Amendments to the Drawings:

REMARKS

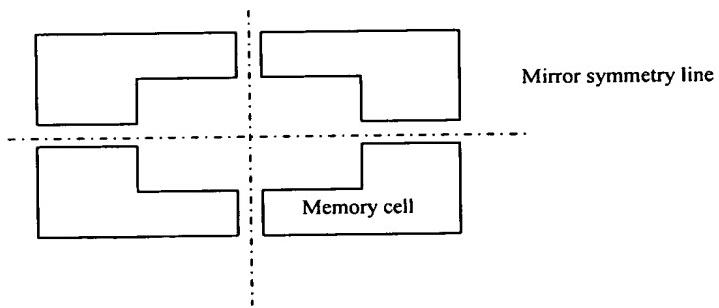
Claim 43 has also been mended to address the issue raised in the Office Action. For the conveniences of the Examiner, applicants point out that this layout is explicitly illustrated in Fig. 30 and is also specified by the following drawing.

FIG. 1

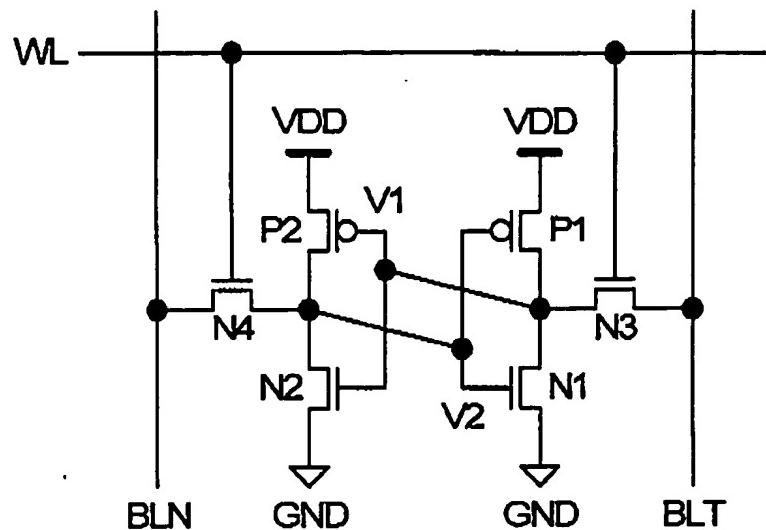
The drawing figures 1-6 have been amended by adding a legend, "Prior Art," as requested by the Examiner. Appended to this amendment is an annotated copy of the previous drawing sheets which have been marked to show changes presented in the replacement sheet of the drawing.

Prior Art

FIG. 2

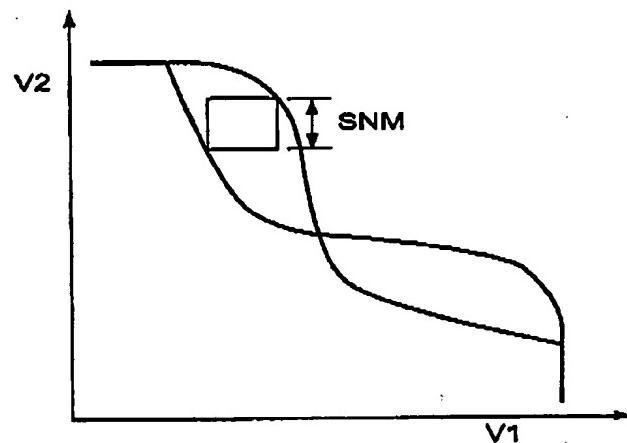
Prior Art

FIG. 3

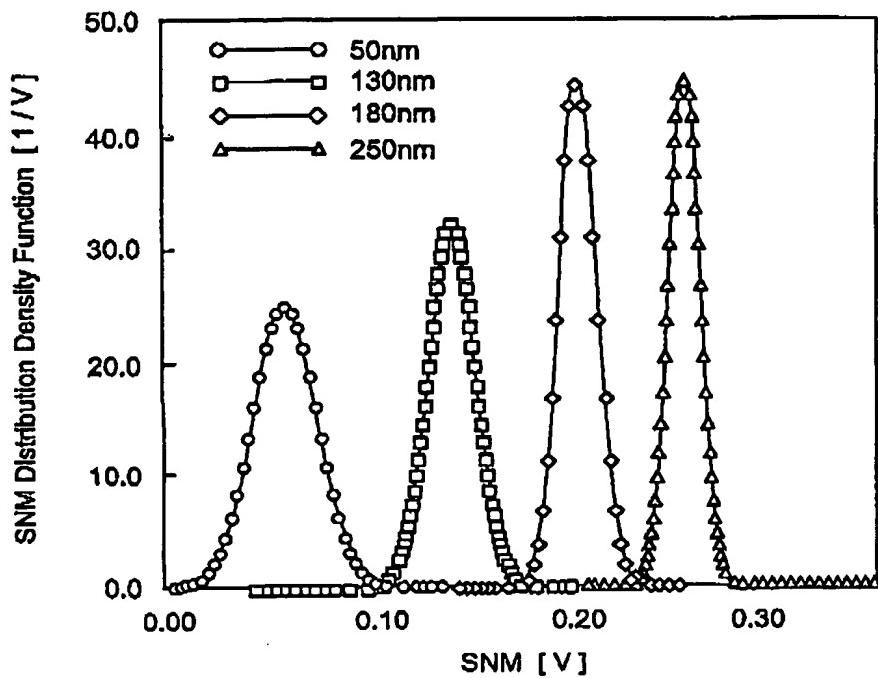
Prior Art

FIG. 4

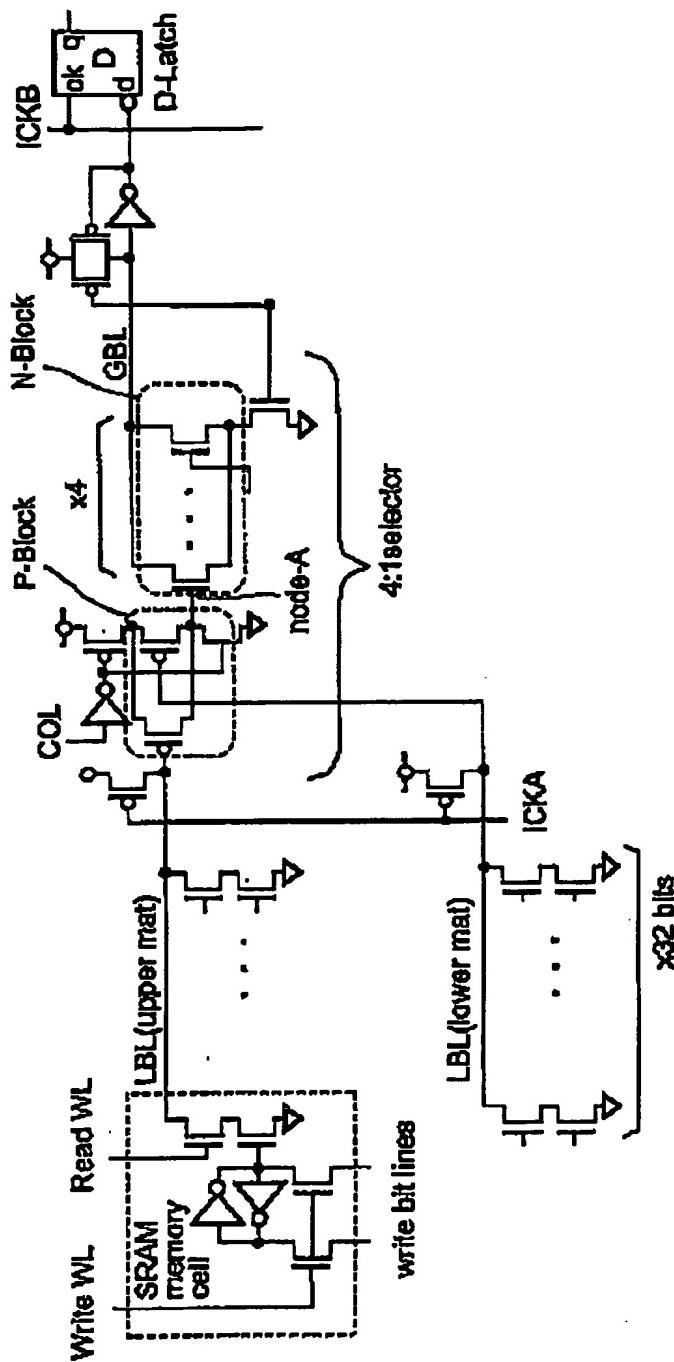
Prior Art

FIG. 5

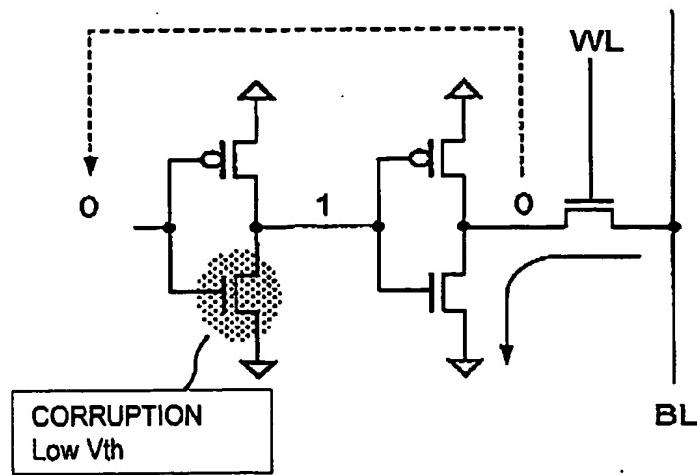
Prior Art

FIG. 6

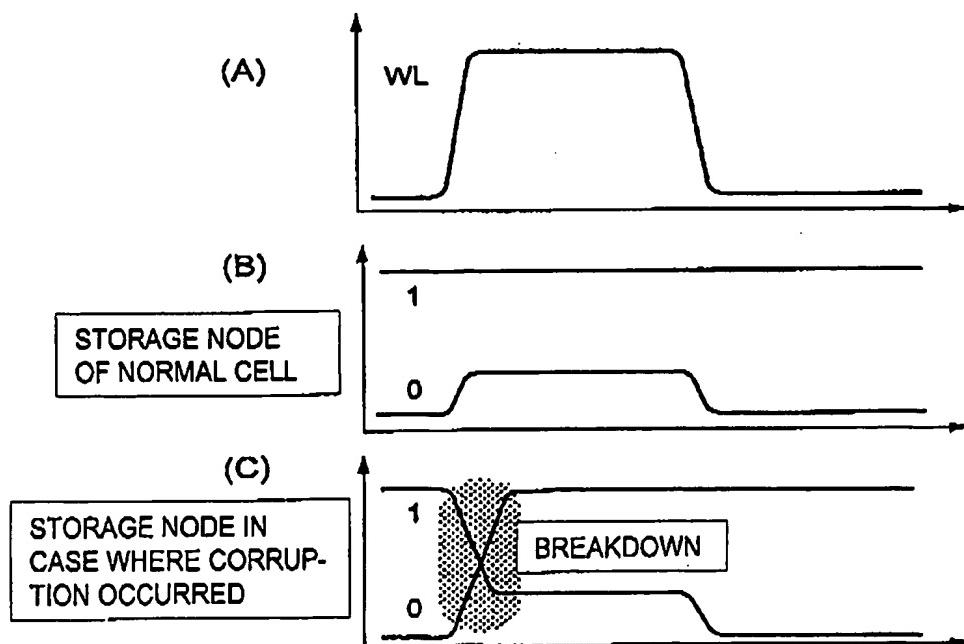
Prior Art
